Clerk to the Panel on Planning, Lands & Works,  
Legislative Council,  
8 Jackson Road,  
The Legislative Council Building,  
Central,  
HONG KONG

REVIEW ON THE DRAINAGE SYSTEMS OF  
RESIDENTIAL BUILDINGS IN HONG KONG

FIGURE 1

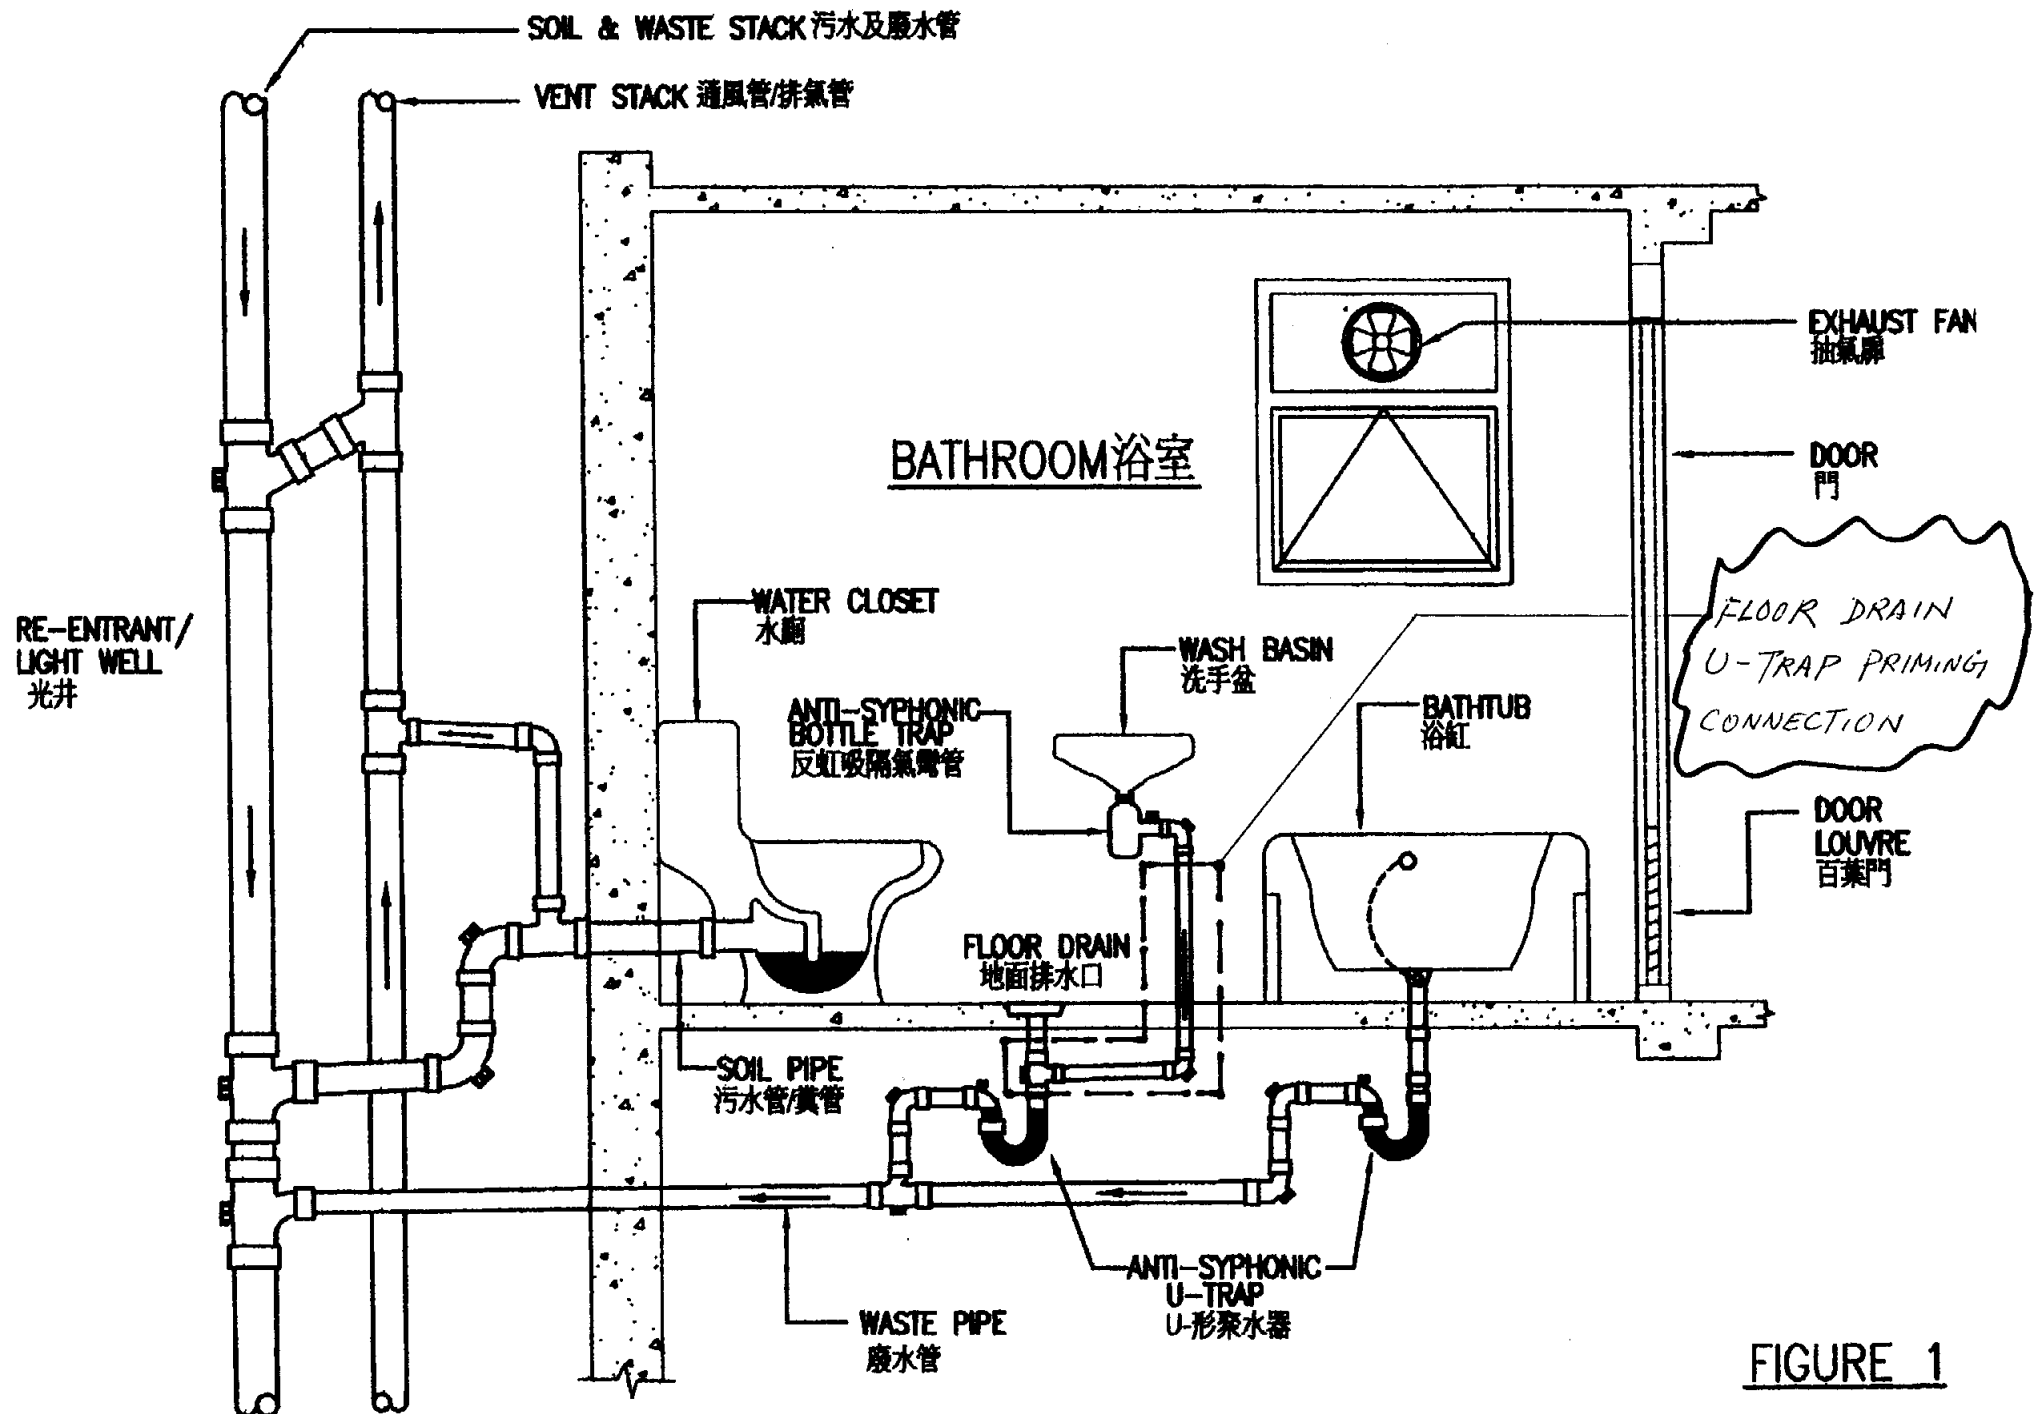
It is highly recommended that the floor drain anti-syphonage U-trap should be automatically and continuously primed. This could be achieved by connecting the wash basin/kitchen sink discharge pipe in between the floor drain grating and its anti-syphonage U-trap *as illustrated in Figure 1 of HKIE report*. The other advantage of which is gaining easy access for the residents to sterilize the floor drains through the wash basin/kitchen sink respectively.
